Fwd: 3-A-13-AC

MPC File # 3-A-13-AC (City Block 49420)

Request to close a portion of an unnamed alley from western boundary of parcels 6 and 11, to the

Re: Right-of-Way Closure Request 3-A-13-AC

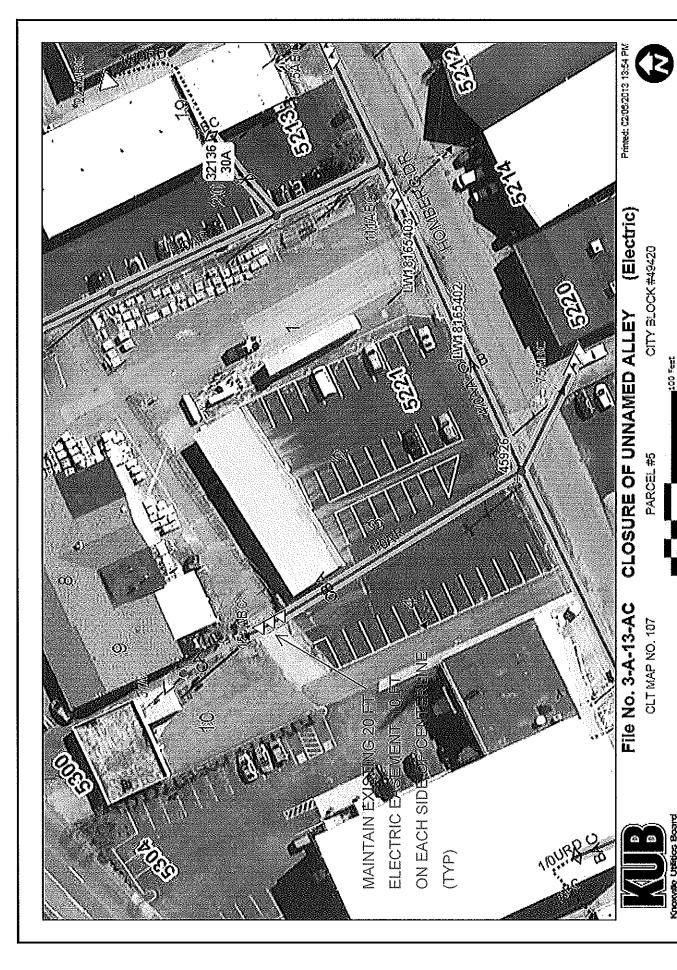
We have reviewed our records and find that we have existing utility facilities located within the subject right-of-way. The approximate location of these facilities is indicated on the enclosed prints. However, KUB does not release and hereby retains all easements and rights for existing utility facilities, whether or not shown on these prints.

Should this right-of-way be closed, KUB will require the following permanent easement for its utility facility.

Electric - 10 feet on each side of the centerline of the electric line, 20 feet total width
